City of Tualatin

CITY ENGINEER'S PUBLIC FACILITIES FINDINGS & RECOMMENDED DECISION

June 24, 2015

Case #: AR-15-05
Project: Koch Expansion
Location: SW 115th Avenue and SW Iteel Street (Tax Map 2S1 27BD Tax Lots 200, 300, and 40) (Tax Map 2S1 27AC Tax Lots 300 and 600)
Applicant: Eric Sporre, PacTrust. (503-603-5492)
Applicant's Rep: Mark Person, Mark Person (503-224-9560)
Property Owner: PacTrust, Eric Sporre (503-603-5492)

SL1.1

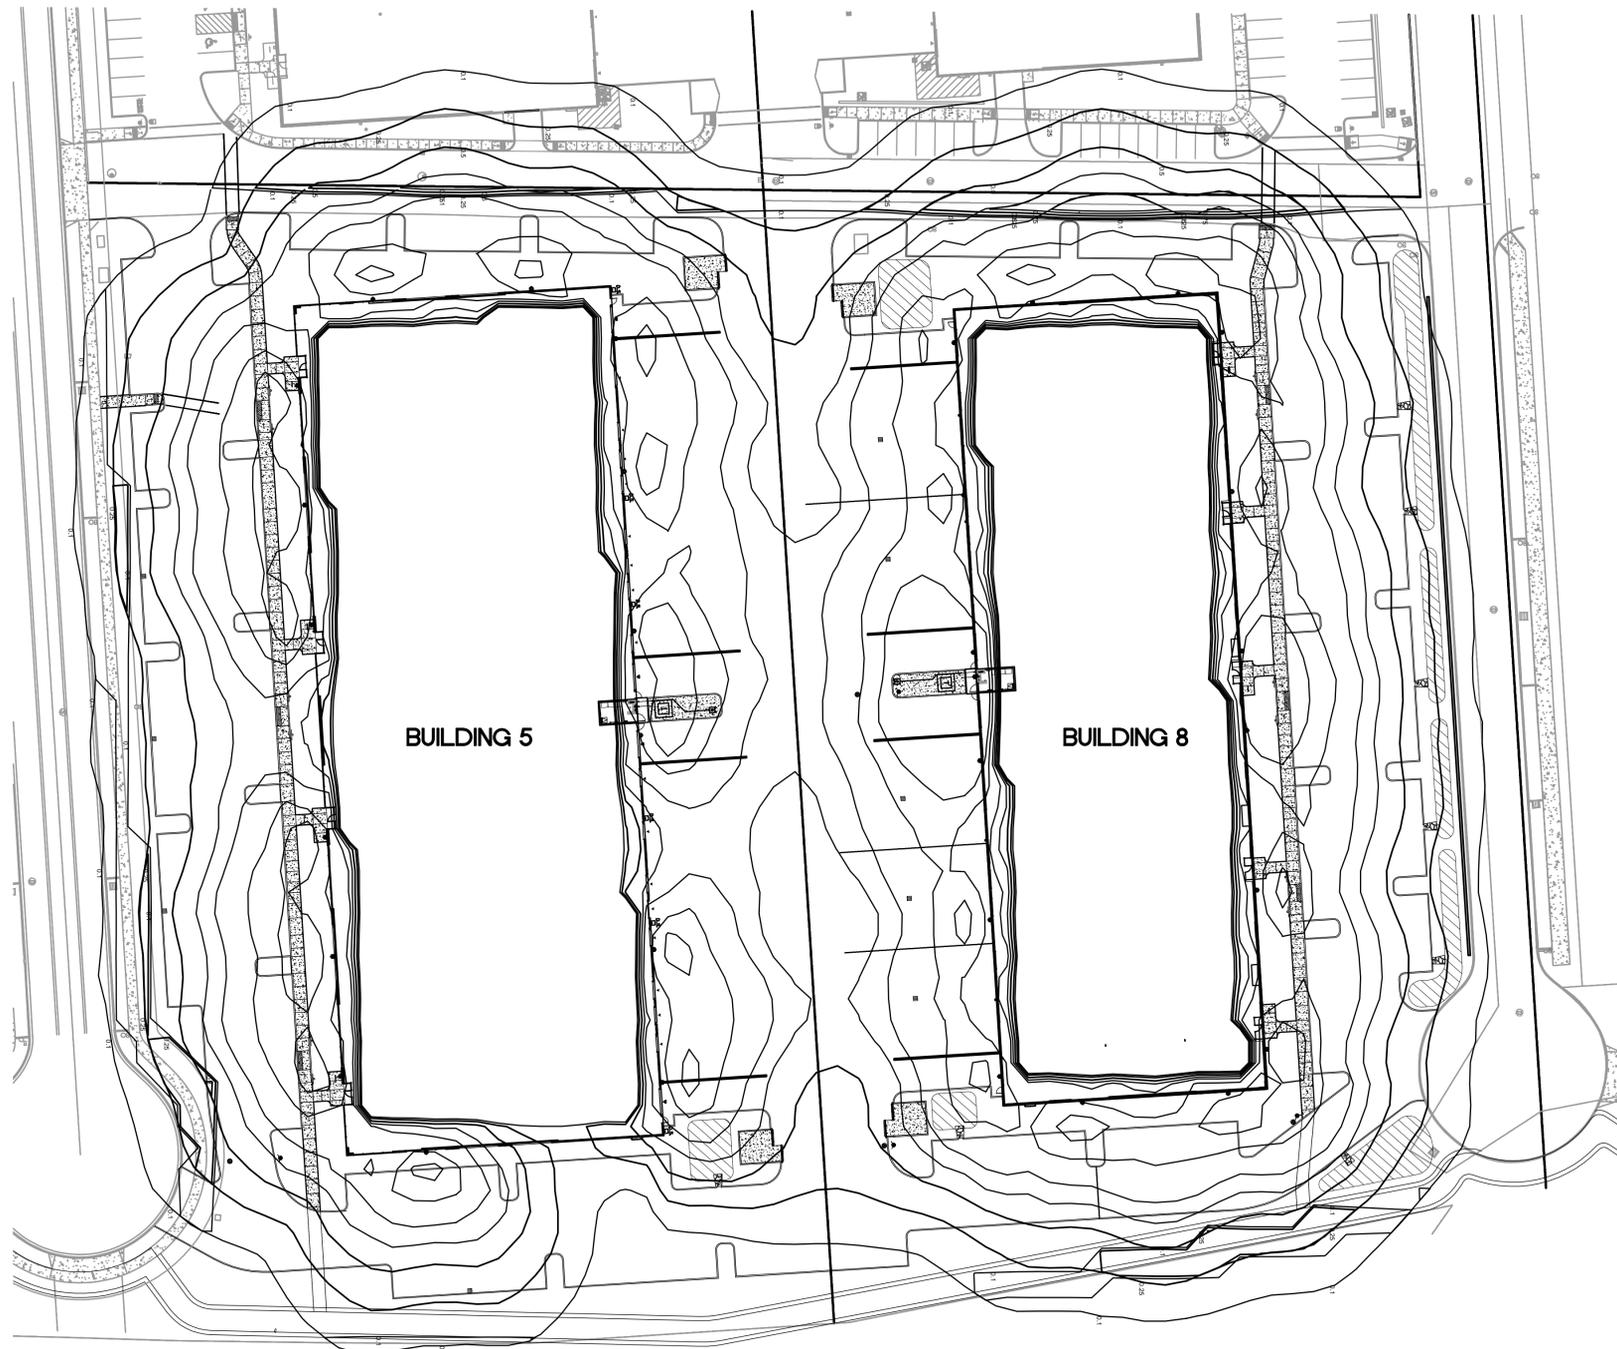
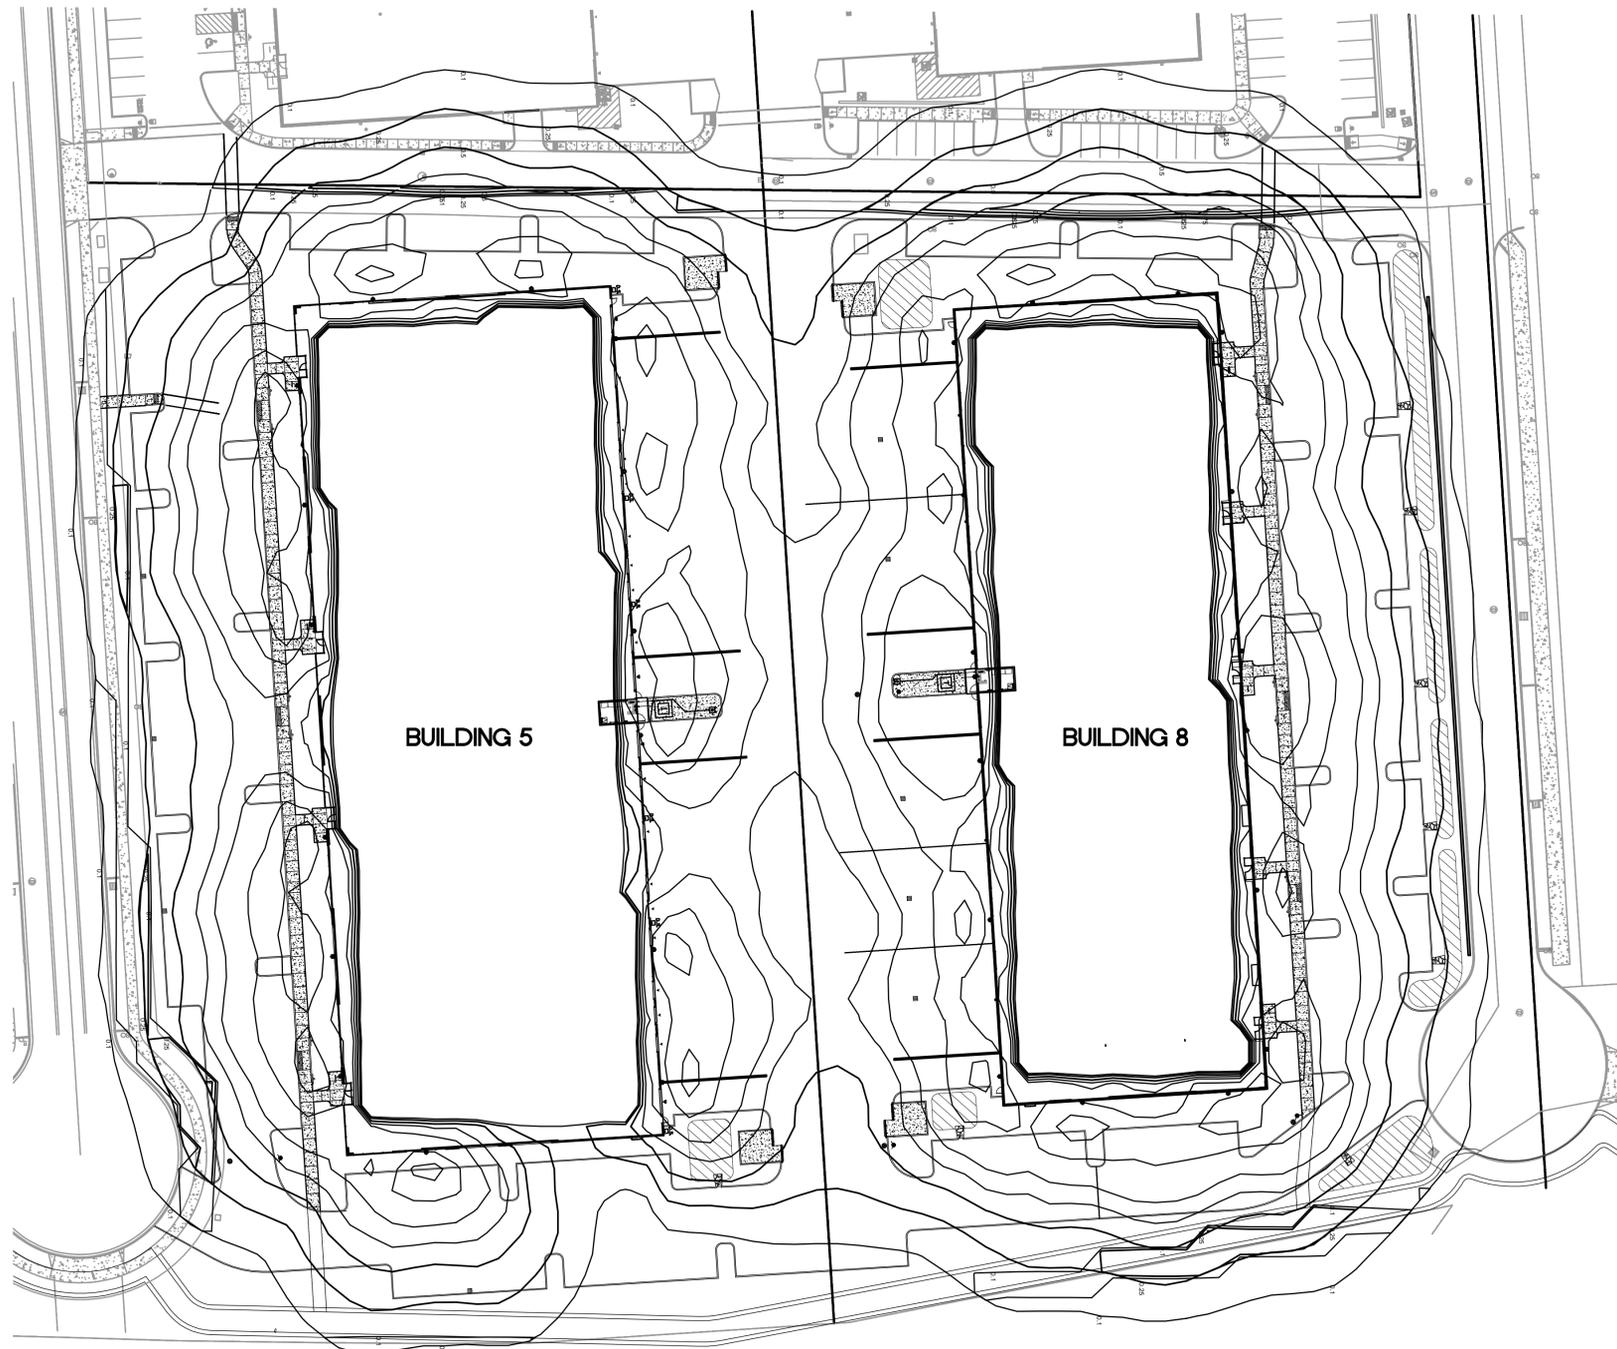
The site photometric plan (Sheet SL1.1) are inadequate to determine lighting measurements as the labels are too small and difficult to read. Staff recommends the applicant provide a revised photometric scatter plan with labels on each reading large enough to be read on a 24 x 36 plan sheet and a safety plan for monitoring trash enclosure areas.

L-1
 OF 2

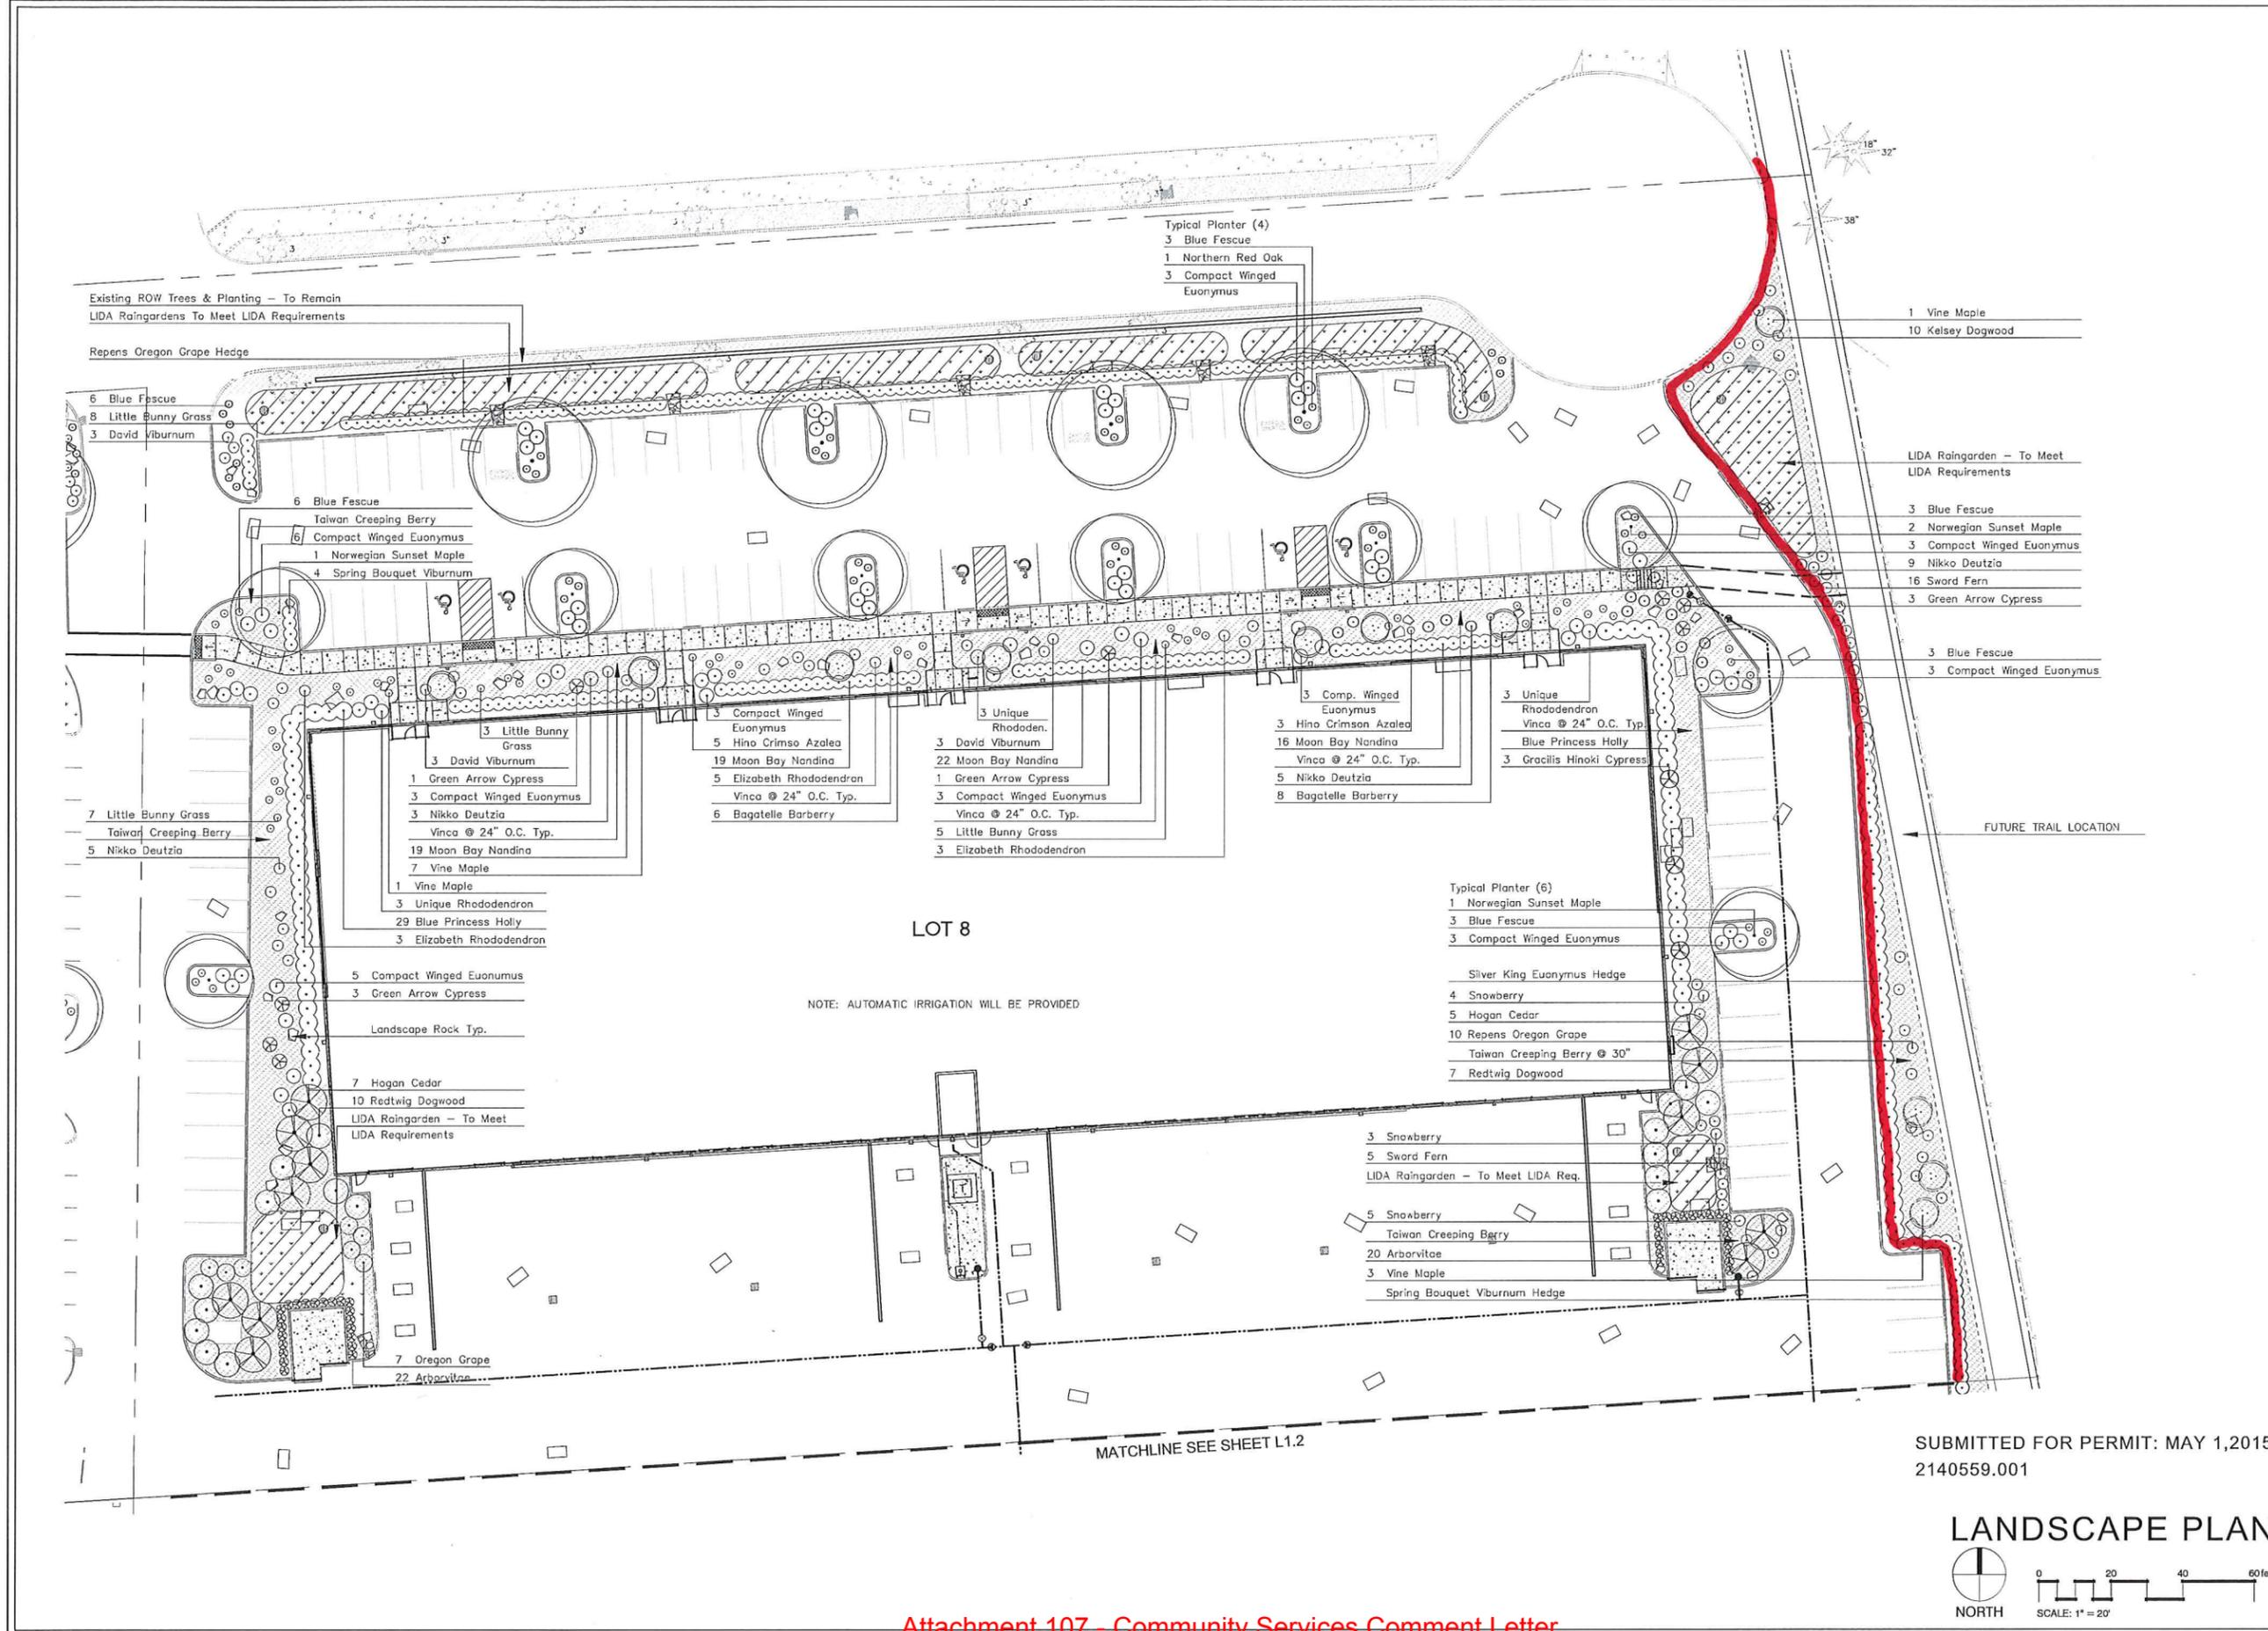
This condition is based on the developer's willingness to voluntarily leave space for the trail. The applicant shall grant an easement to accommodate a 14 foot shared use pathway per approved Ice Age Tonquin Trail Master Plan. The easement area shall vary in width between 14 and 20 feet along the eastern property boundary as shown on attached Site Plans L-1, L-1.1 and unnamed.

- *The applicant shall grant an easement to accommodate a 14 foot shared use pathway varying in width between 14 and 20 feet along the eastern property boundary as shown on attached Site Plans L-1, L-1.1 and unnamed, for review and approval.*

- PFR-16 The applicant shall grant an easement to accommodate a 14 foot shared use pathway varying in width between 14 and 20 feet along the eastern property boundary as shown on attached Site Plans L-1, L-1.1 and unnamed, for review and approval.
- PFR-17 The applicant shall submit a copy of the recorded private access agreement, for review and approval.
- PFR-18 The applicant shall submit a copy of the private water easements for Buildings 5, 8, and the two lots to the west, for review and approval.
- PFR-19 The applicant shall complete all the public improvements and have them accepted by the City.

The applicant will need to grant an easement to accommodate a 14 foot shared use pathway varying in width between 14 and 20 feet along the eastern property boundary as shown on attached Site Plans L-1, L-1.1 and unnamed (3 pages), for review and approval.
